Subject: **Bid No. 8819-M7 – Sprinkler & Fire Alarm Modifications – Union Station / WRA**

ADDENDUM NO. 3

SPRINKLER AND FIRE ALARM
MODIFICATIONS PHASE 2
UNION STATION
WORCESTER, MA

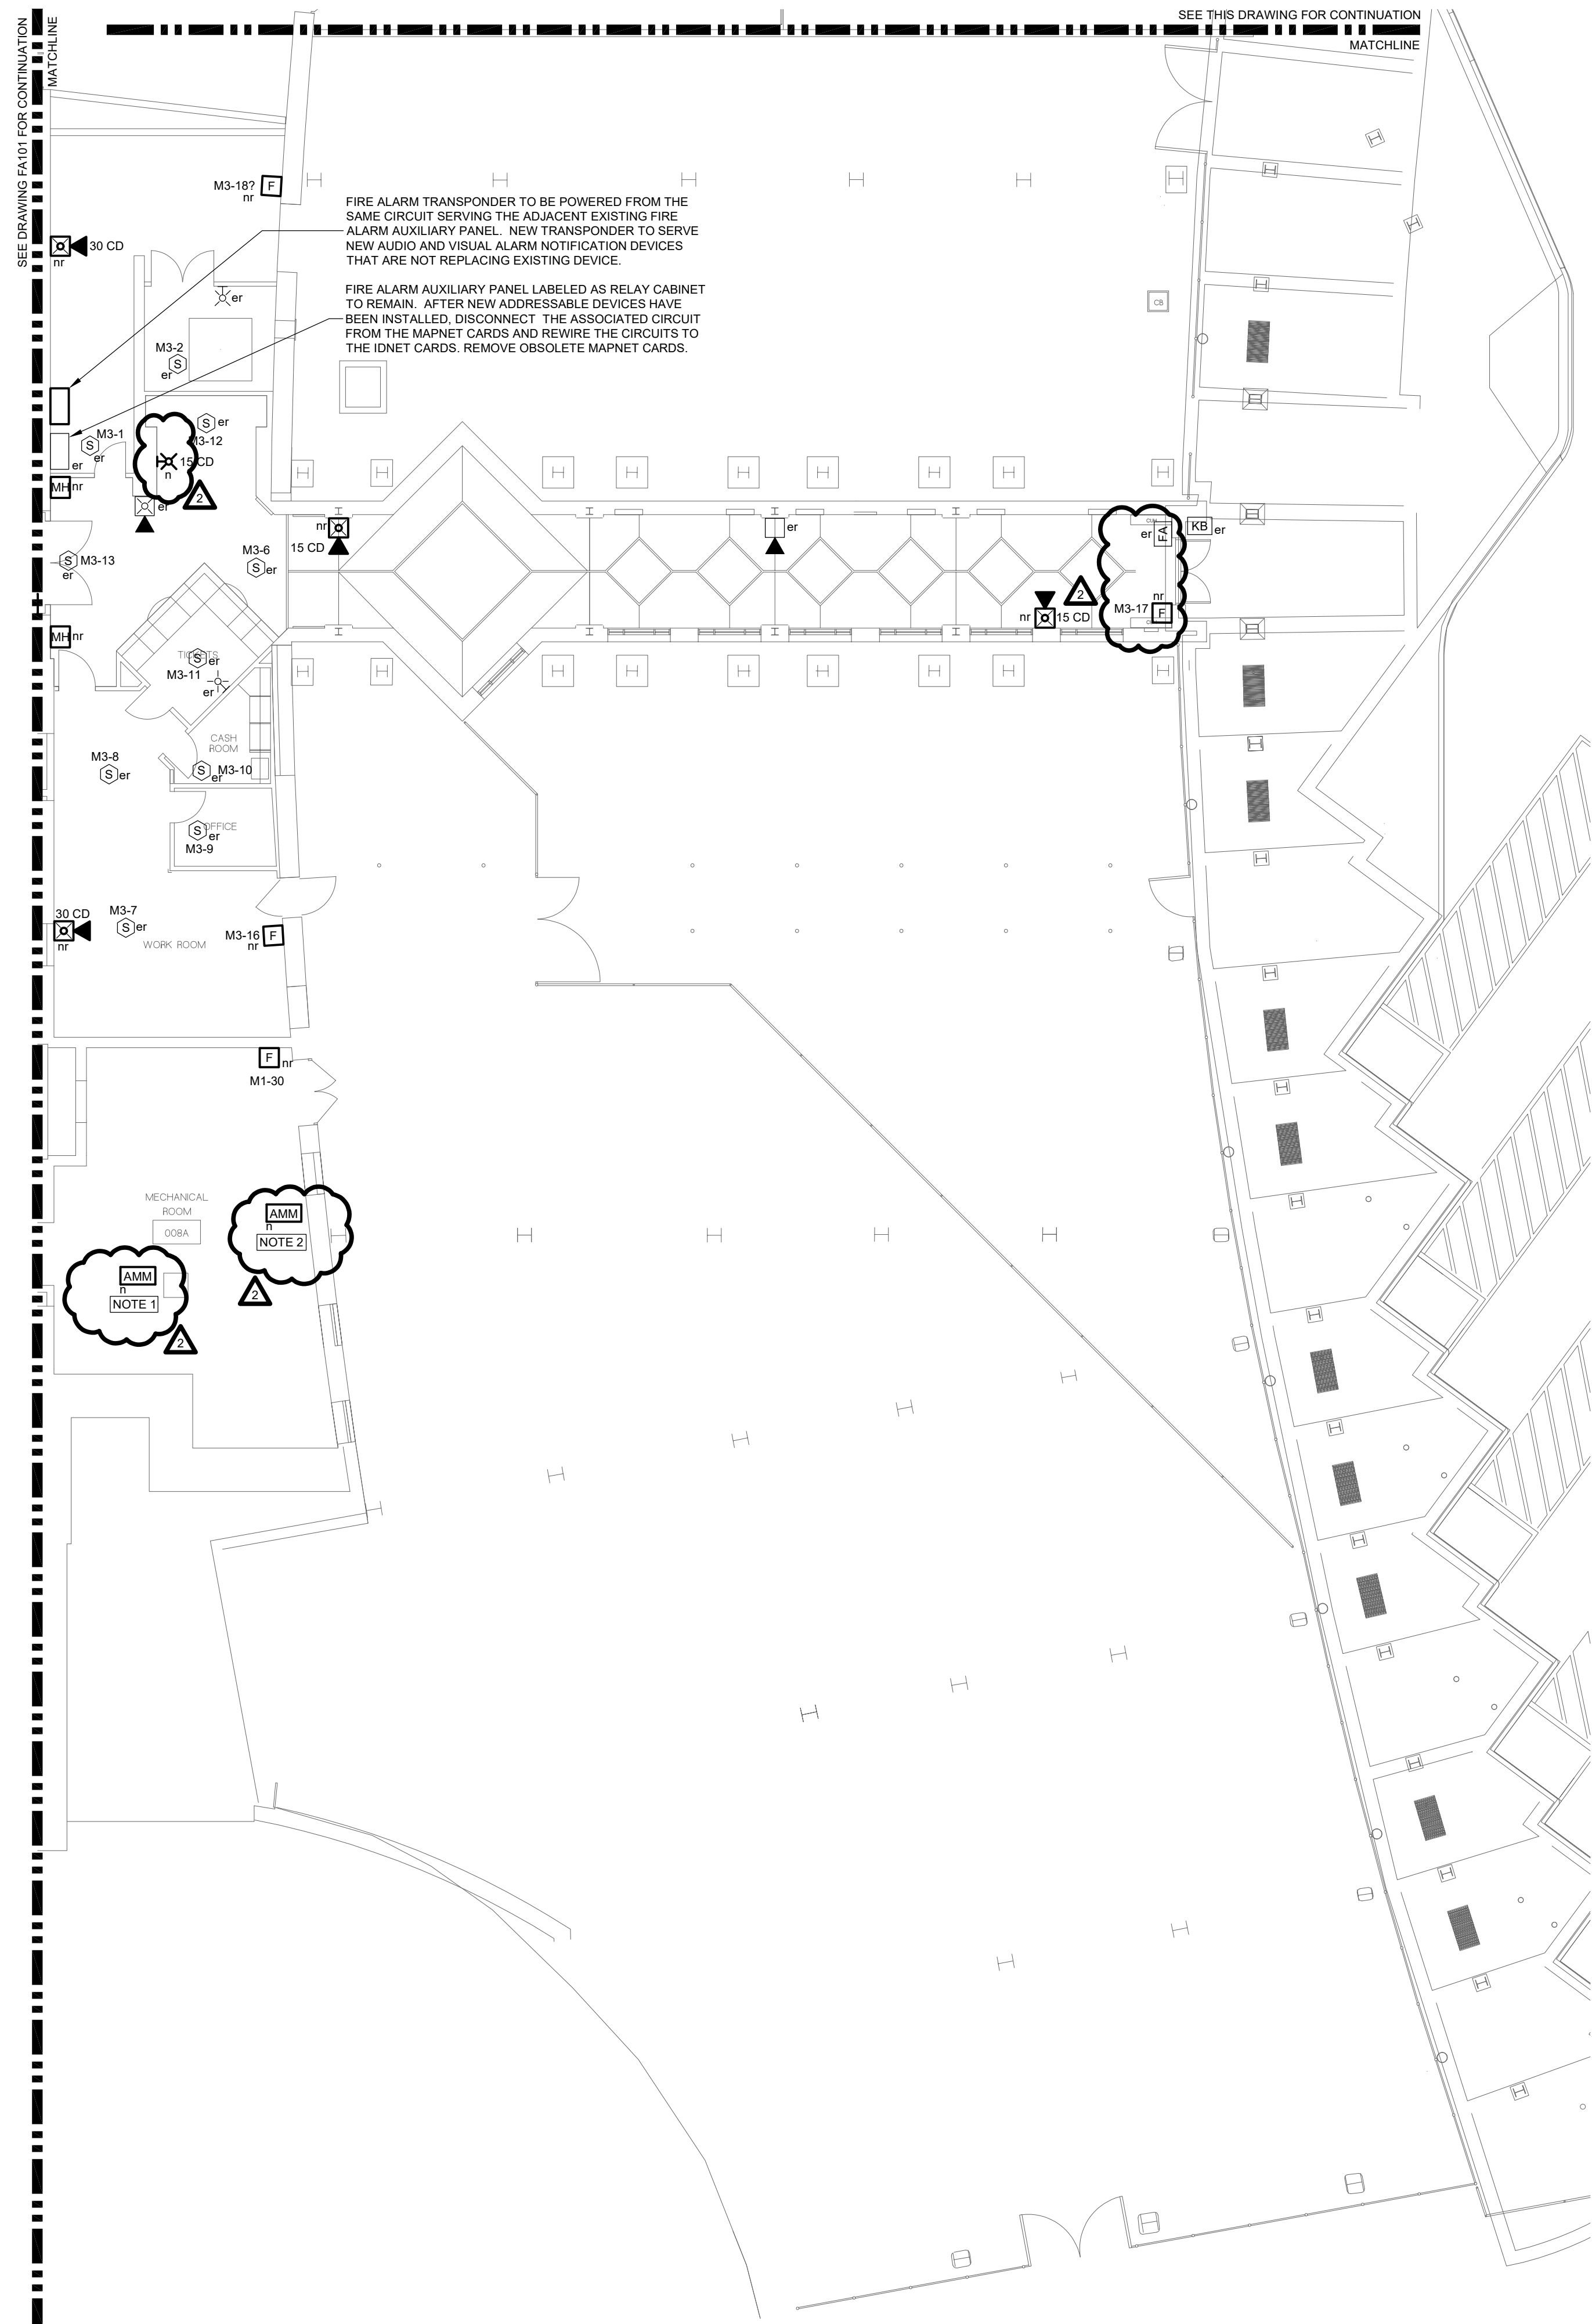
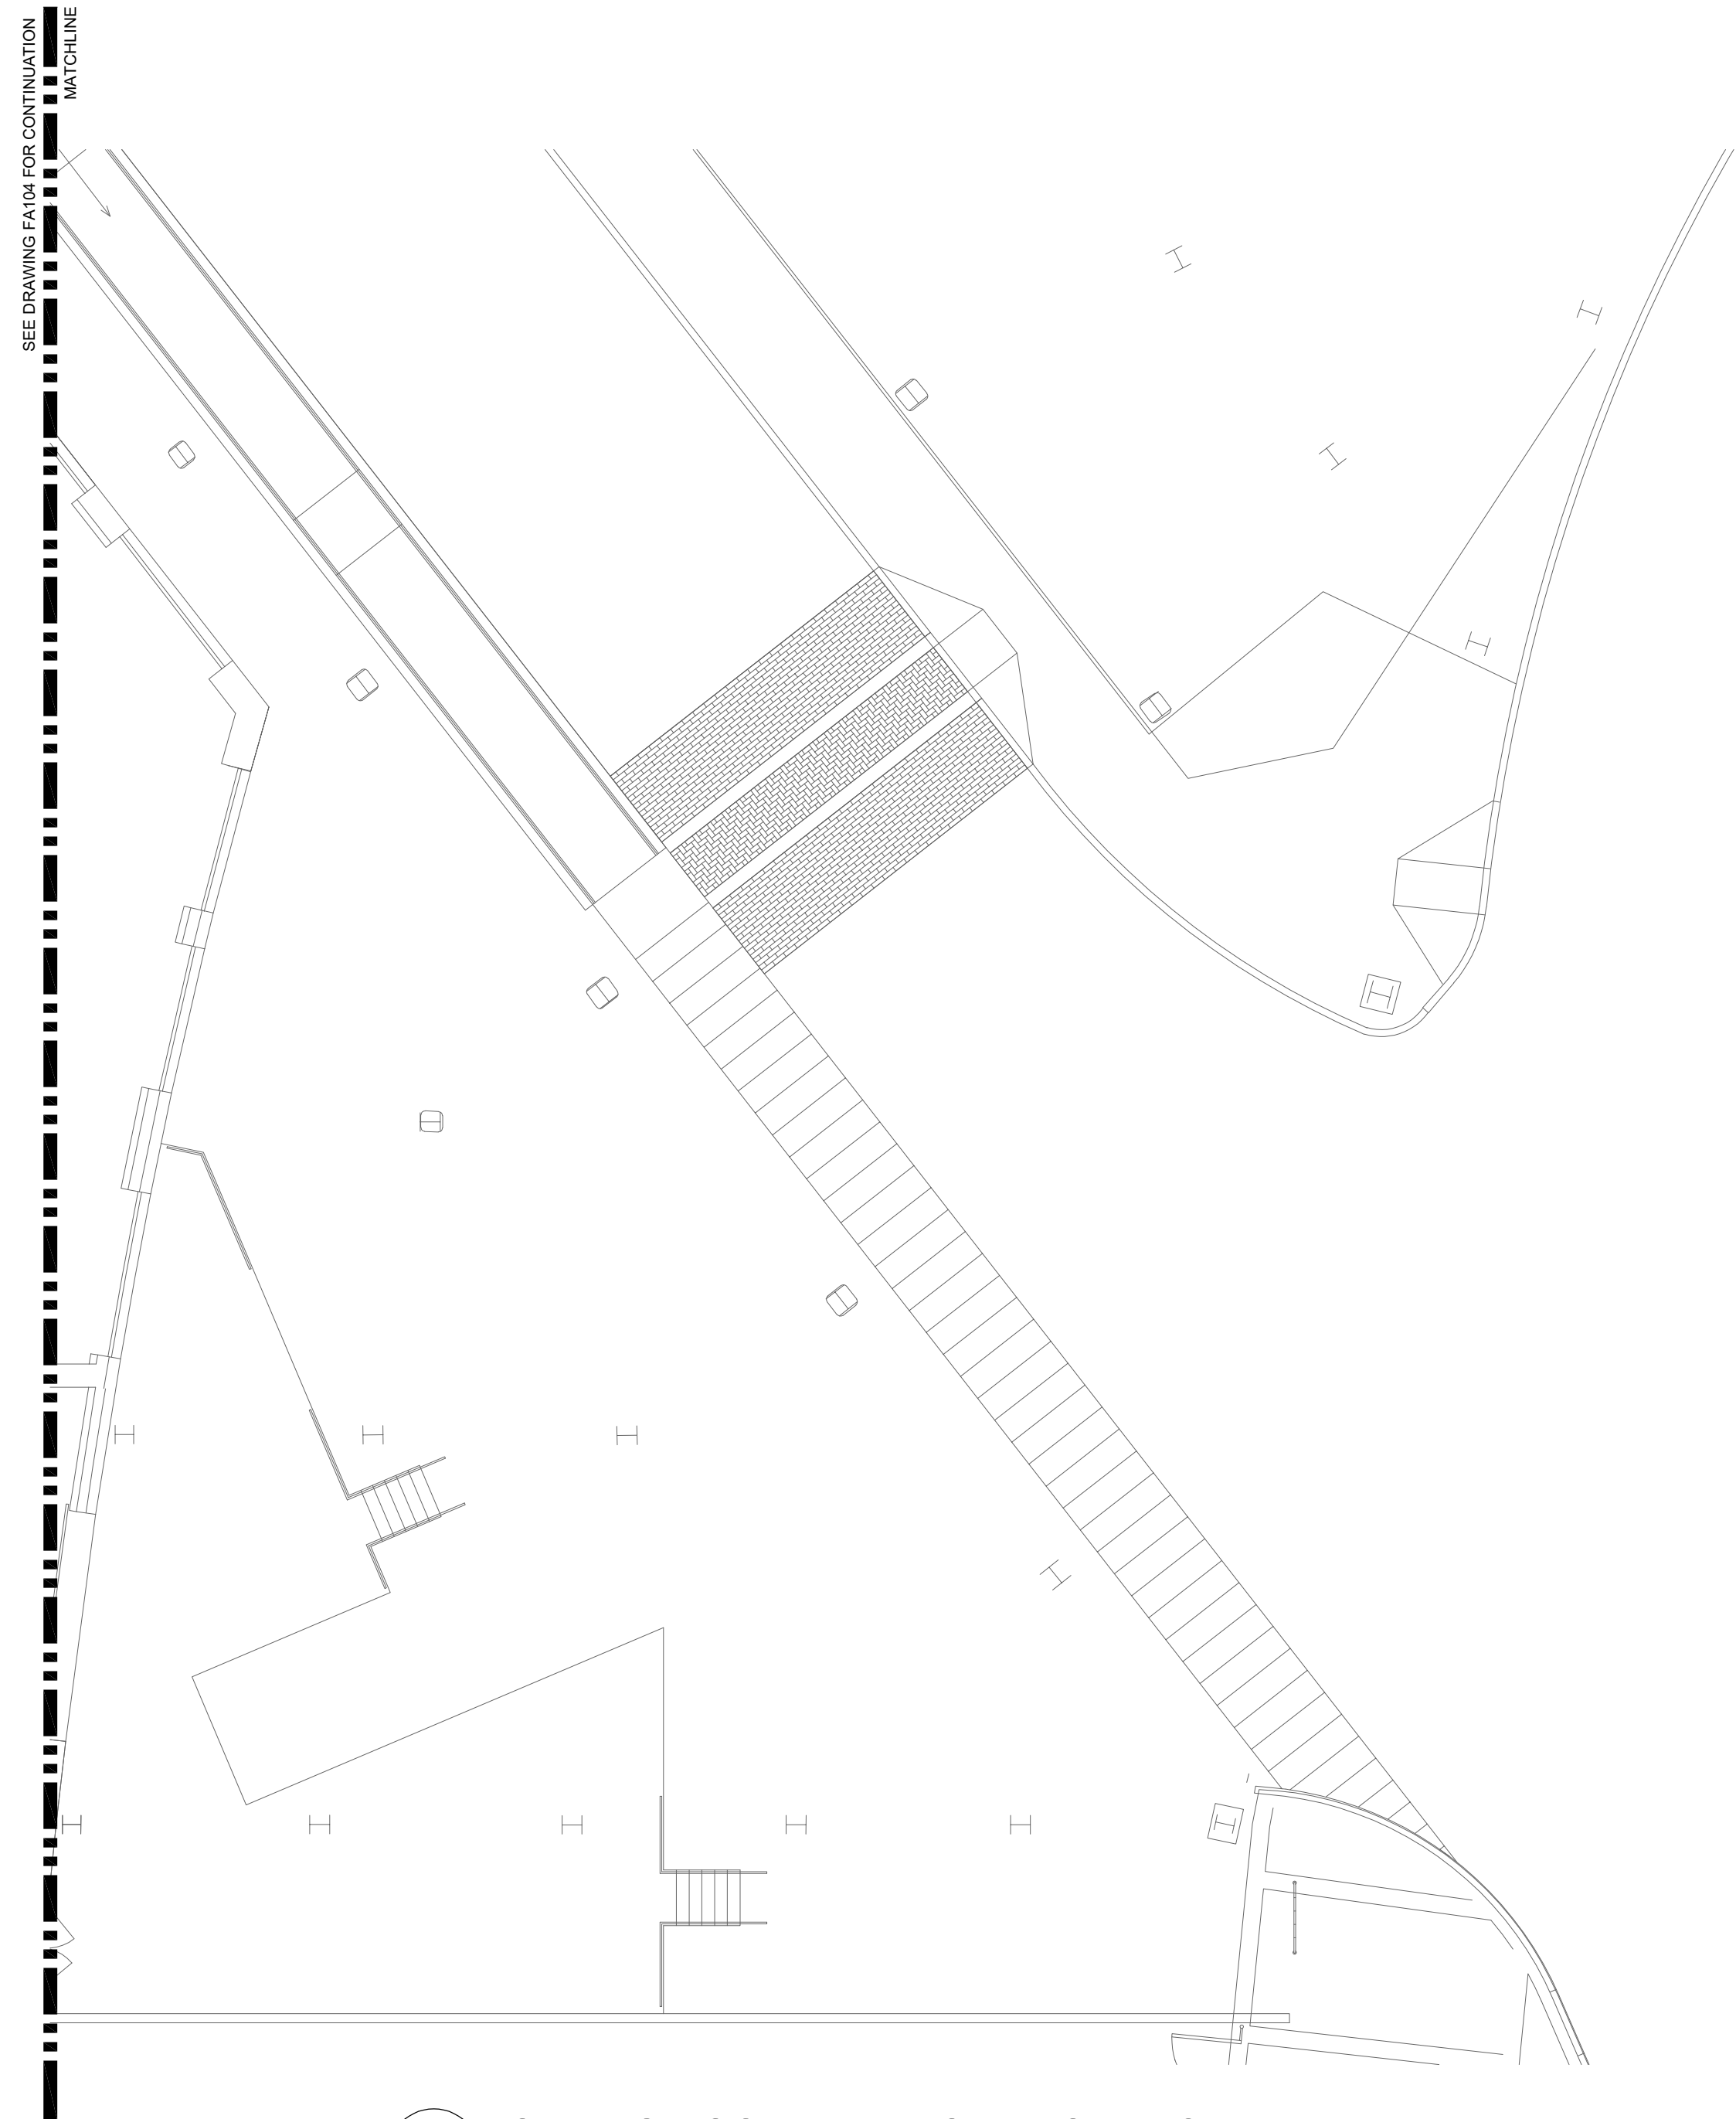
Drawing FA102, Electrical Fire Alarm Partial Basement and Bus Terminal New Work Plan, Revise as follows:

- REVISE pull station M3-17 from “Existing to Remain” to “New to Replace Existing”.
- REVISE fire alarm annunciator panel from “New to Replace Existing” to “Existing to Remain”.
- ADD addressable monitor module for leak detector controller monitoring and associated Keyed Note 1.
- ADD addressable monitor module for temperature sensor controller monitoring and associated Keyed Note 2.
- ADD notation for new strobe with “n”

Q: FA102: Is the 15CD Strobe-only device shown near ER Smoke M3-12 existing to remain or a brand-new device? FAD102 doesn't show the device at all, and although it appears in **BOLD** on FA102, there is no notation near it indicating its actual status.

A: The strobe is a new device/location.

FA103

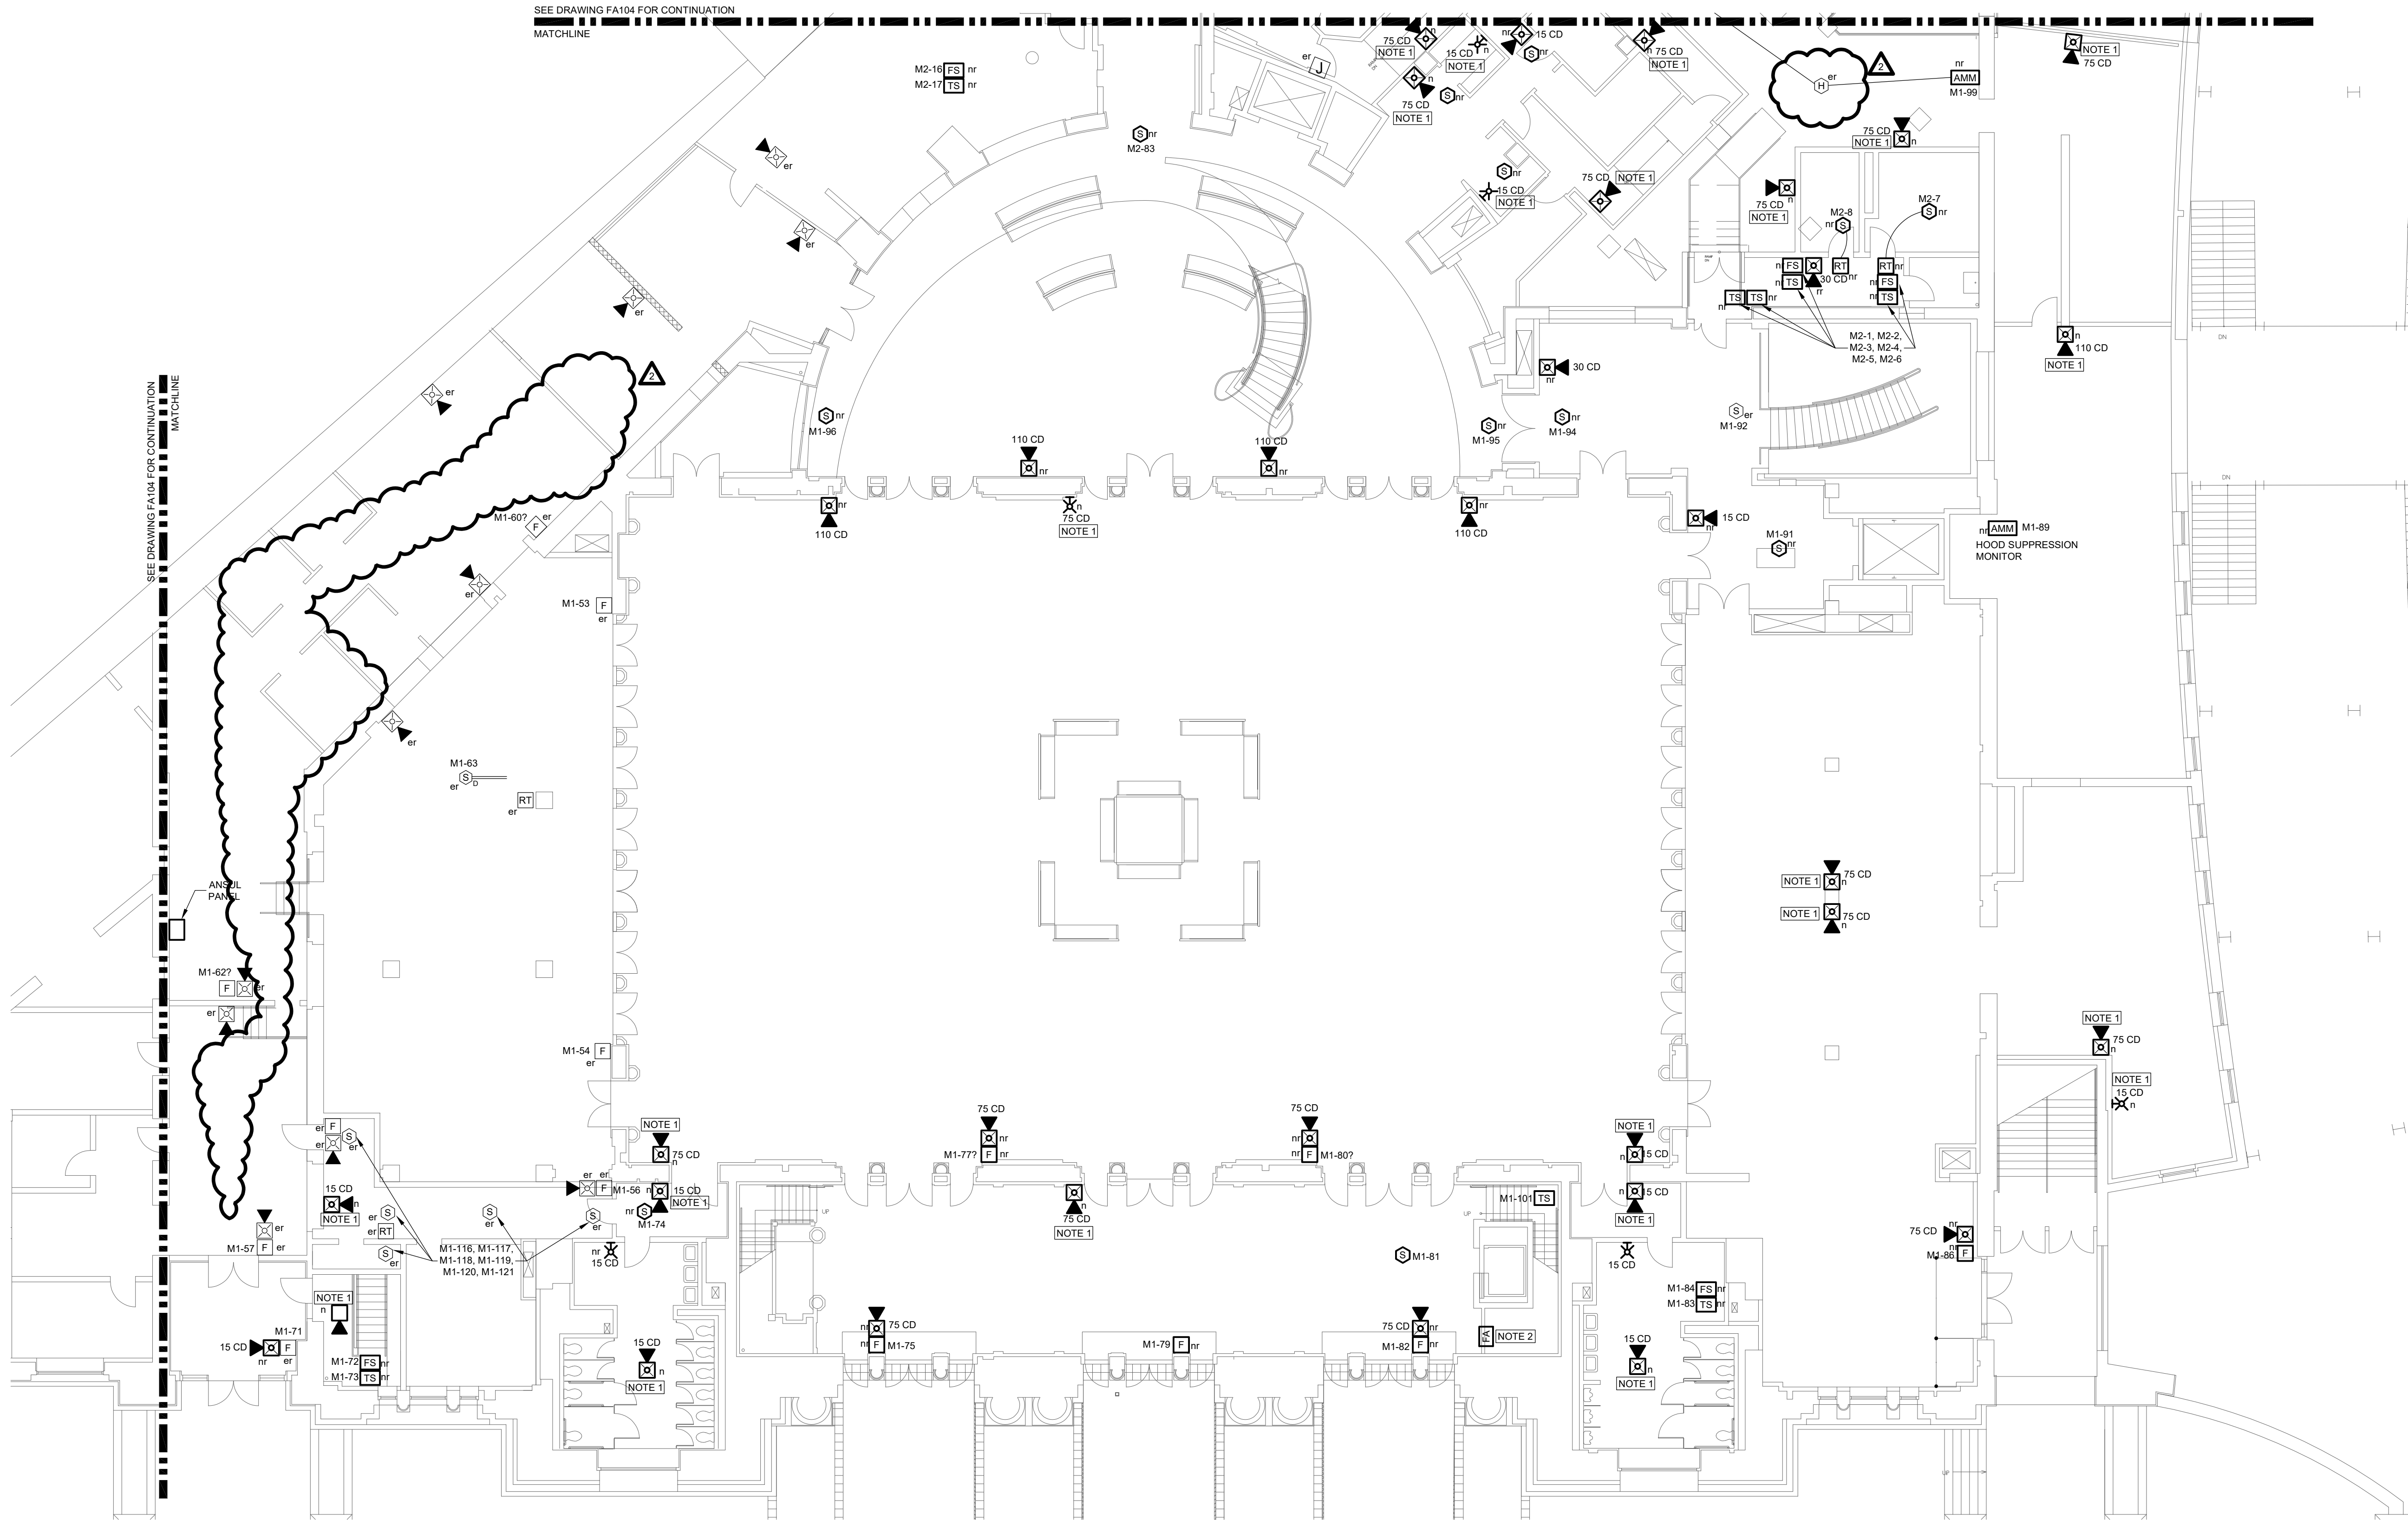
Drawing FA103, Electrical Fire Alarm First Floor New Work Plan, Revise as follows:

- ADD missing heat detector to remain monitored by addressable monitor module M1-99.
- DELETE wiring shown for demolished heat detectors from addressable monitor modules for address points M1-65 and M1-66.
